Official Transcript of Proceedings  
NUCLEAR REGULATORY COMMISSION

Title: Advisory Committee on Reactor Safeguards  
ABWR Subcommittee on STP COLA

Date: Tuesday, October 2, 2012

ABWR SUBCOMMITTEE ON STP COLA

# Study for Debris Modeling

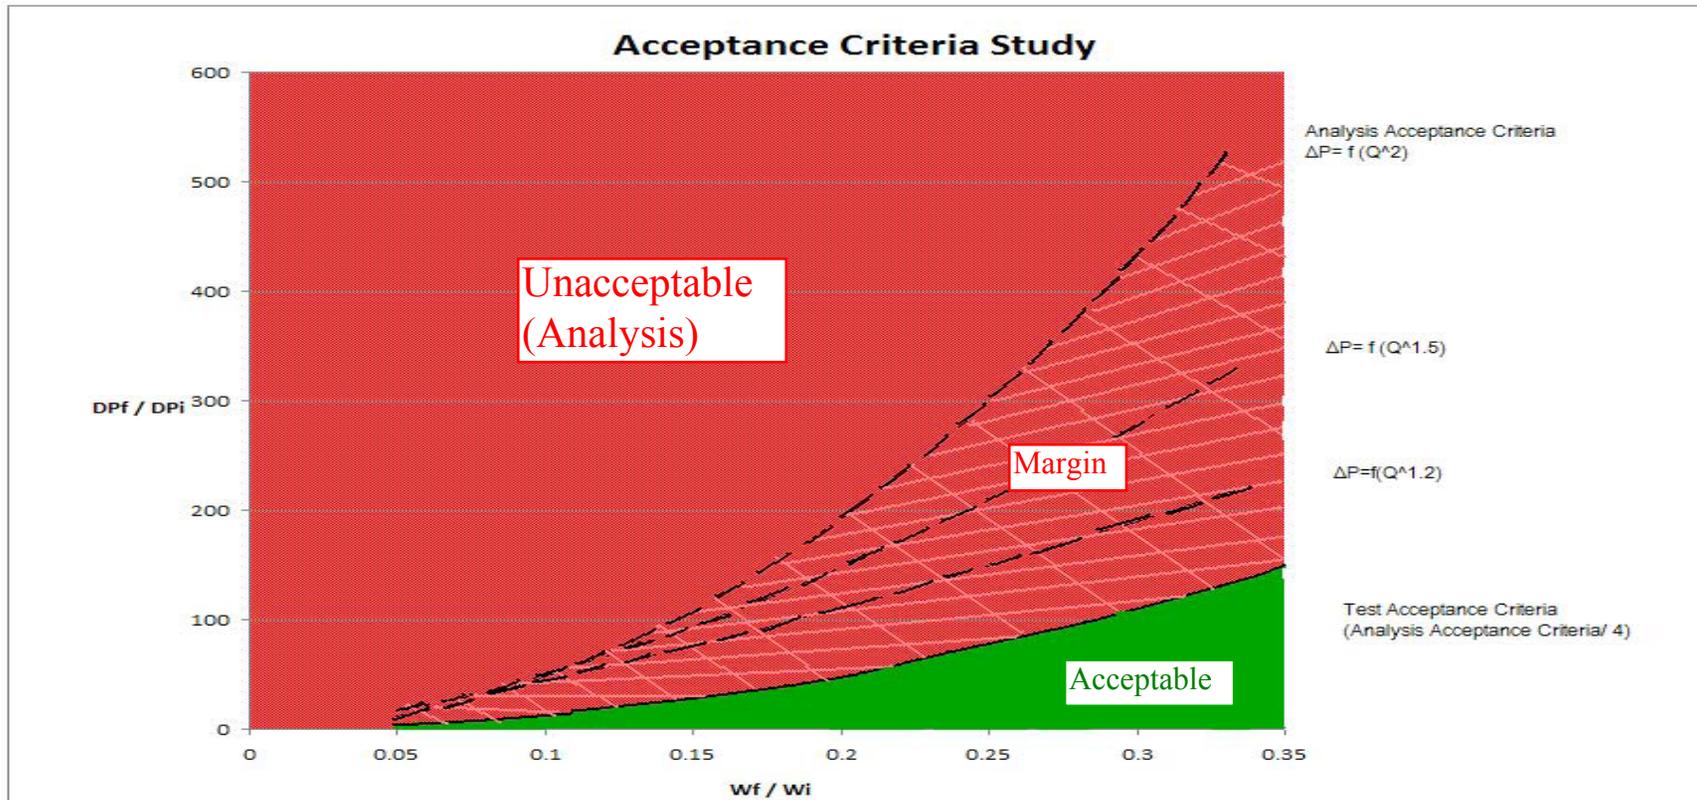
- The following overhead provides example calculations of the analysis acceptance criteria using different debris pressure drop vs. flow rate (Q) relationships
  - $\Delta P = f(Q^{1.5})$
  - $\Delta P = f(Q^{1.2})$
- These are compared with the analysis acceptance criteria (using  $\Delta P = f(Q^2)$ ) and the conservative test acceptance criteria (based upon  $\Delta P = (1/4) f(Q^2)$ )

## Follow-up Item # 80 - Conclusion

- The conservative test acceptance criteria bounds the debris pressure drop vs. flow dependency variations.
- As discussed previously we believe the test acceptance criteria is appropriate and conservative
